**Economic and Social Council**Distr.: General
16 February 2017

Economic Commission for Europe**Inland Transport Committee****World Forum for Harmonization of Vehicle Regulations****Working Party on Passive Safety****Sixty-first session**

Regulation No. 44 (Child restraint systems)**Proposal for Supplement 13 to the 04 series of amendments
to Regulation No. 44 (Child Restraint Systems)****Submitted by the expert from the Netherlands***

Figures of Strapped child

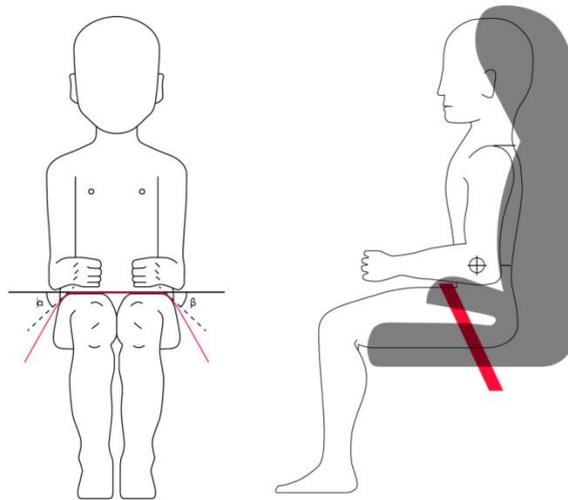
Paragraph 6.2.2., amend to read:

"6.2.2. For groups I, II and III, all restraint devices utilizing a "lap strap" shall positively guide the "lap strap" **on both sides** to ensure that the loads transmitted by the "lap strap" are transmitted through the pelvis. The assembly shall not subject weak parts of the child's body (abdomen, crotch, etc.) to excessive stresses. **The positive guidance of loads over the pelvis shall be realized from the moment that the child is installed; the lap belt shall pass rearward on the thighs, just touching the fold with the pelvis. The angles α and β between the tangent line in which the belt touches the thighs and the horizontal shall be greater than 10°.**

"Figure 1B

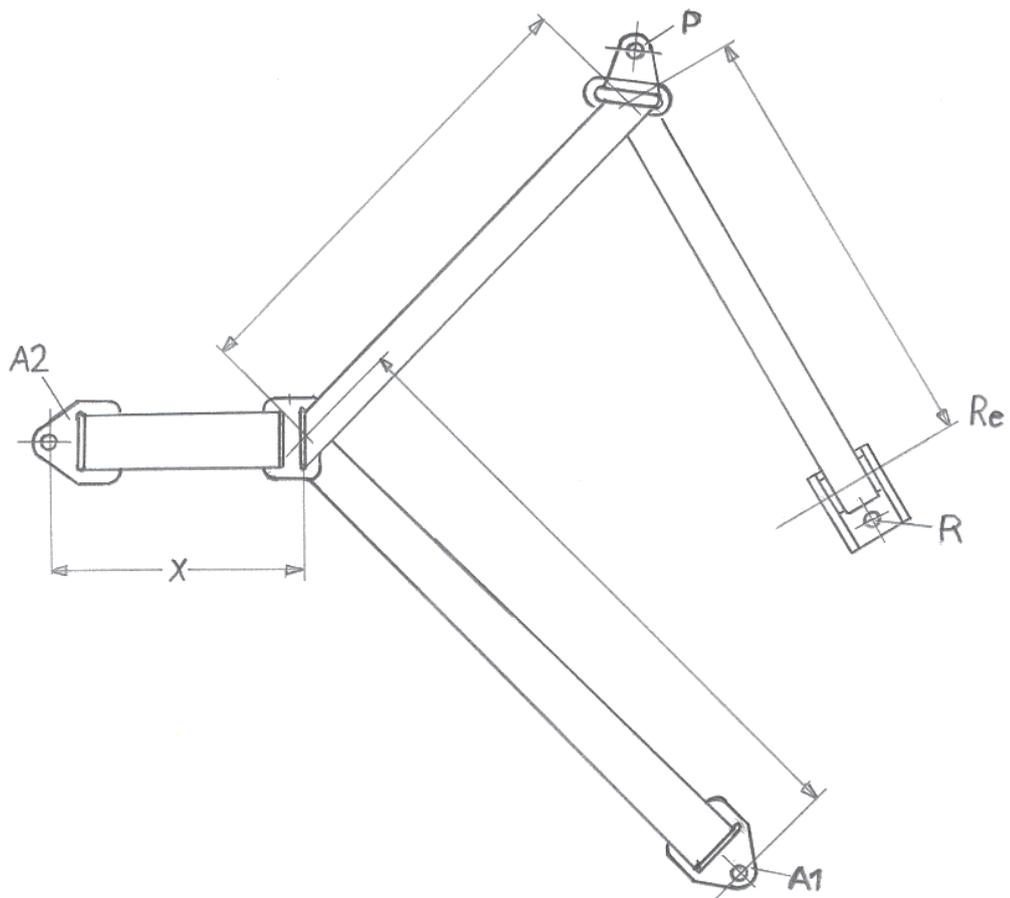
Figure 1B, amend to read:

Figure 1C
Standard seat belt configuration, for fitting session of par.6.2.12.

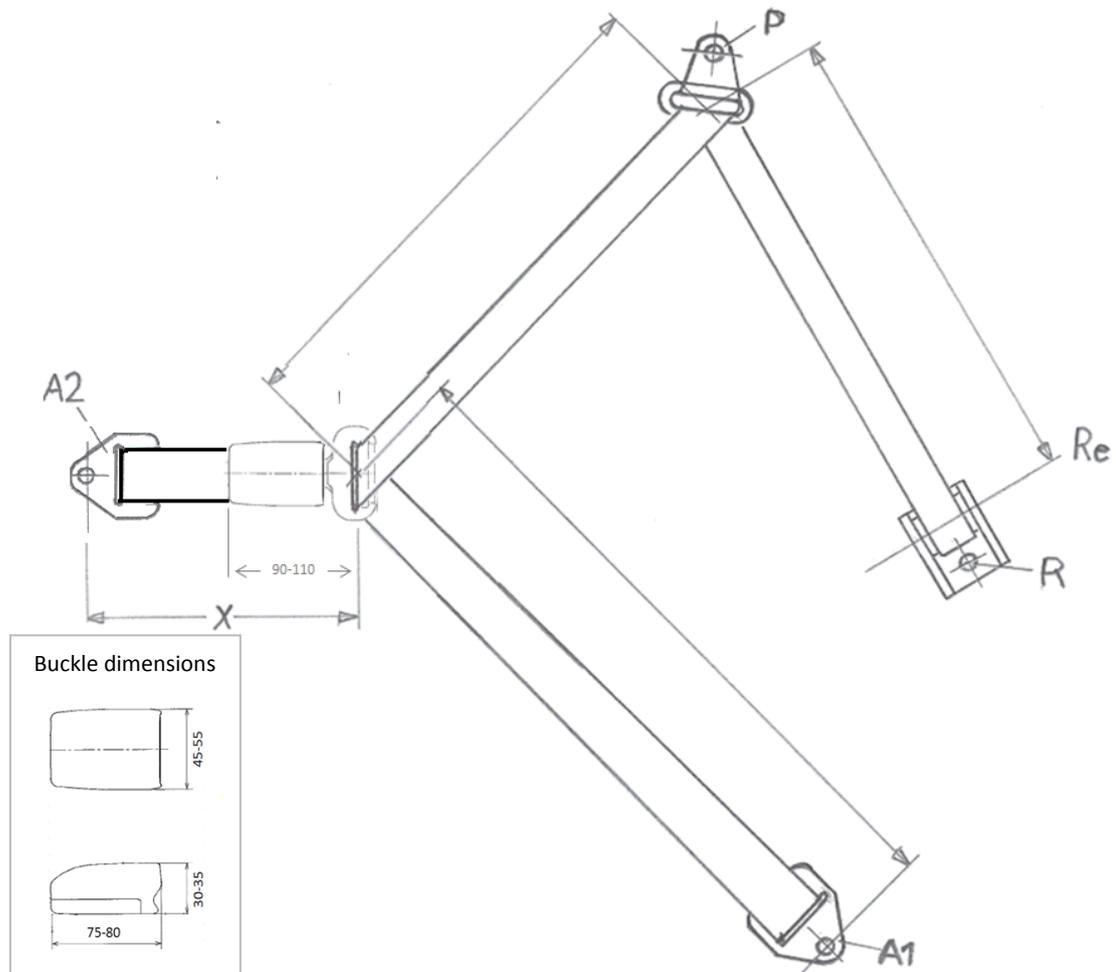
"6.2.12. In case of ~~booster cushions~~ **non-integral child restraint systems**, the ease with which the straps and tongue of an adult belt pass through the fixture points shall be examined. ~~This goes particularly for booster cushions which are designed for the front seats of cars, which may have long semi-rigid stalks.~~ The fixed buckle + **tongue** should not be allowed to pass through the fixture points of booster seats, or to permit a lie of belt completely different from that of the test-trolley.

This shall be tested during a separate fitting session on the test bench by replacing the central part of the standard safety belt (figure 3 of Annex 13) and the flexible strap to part A2, with respectively, a tongue and a generic buckle attached to a flexible strap with an adapted length such that, the combination of A2, adapted flexible strap buckle and tongue are projecting 150 mm outside the Cr point."

Insert new Figure 1C, to read:

3. The type approval administration of the Netherlands is confronted with a CRS that forces the lie of the adult belt in real cars completely different from the lie on the test-trolley. Regulation No. 44 mentions a judgment using buckles, but does not further specify anything about a proper judgment. To prevent incompatibilities with real cars, this paragraph aims to introduce a better check.
